NYCT IDLER BEARING REPLACEMENT

Prevost vehicles

DESCRIPTION

FIG.1 ALTERNATOR IDLER AND A/C TENSIONER PULLEY

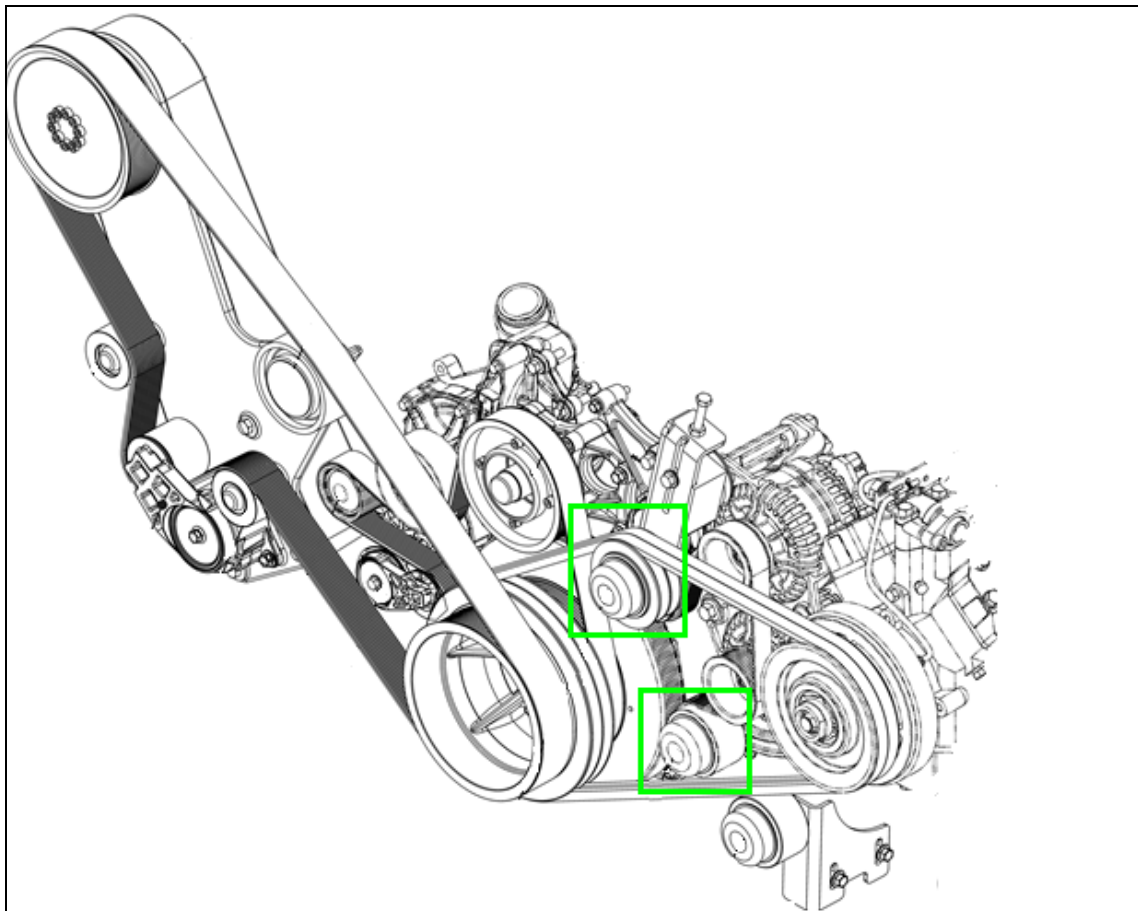
On the vehicles affected by this bulletin, proceed to the replacement of the original A/C tensioner and alternator idler bearings with a FAG branded unit following the procedure outlined below.

These FAG bearings are of heavier duty construction and will offer extended durability compared to the original ones.

1. Open the vehicle rear engine door and locate the two pulleys (A/C tensioner # 457505 and alternator idler # 457705) requiring the bearing replacement (Fig.1).

FIG.4 A/C TENSIONER AND ALTERNATOR IDLER BEARING REMOVAL / INSTALLATION

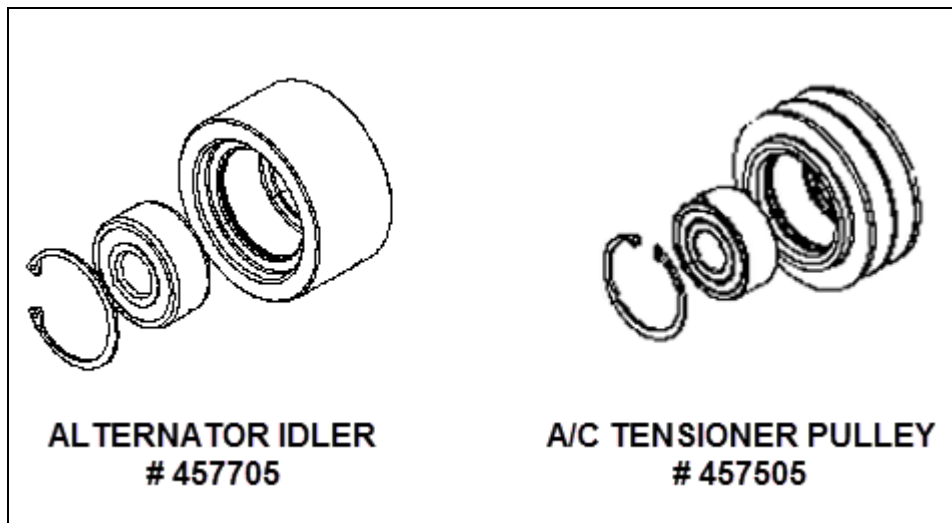
NOTE: Procedure to remove and replace bearings is identical for both pulleys. Refer to Figure 4 below for installation.

1. Remove the pulley inner snap rings using appropriate snap ring pliers.
2. Using a suitable bearing removal tool, press off the bearing out of the pulley assembly.
3. Still using suitable tools, insert a new bearing # **507014** into the pulley body until it bottoms out in the pulley body.
4. Reinstall the snap rings.
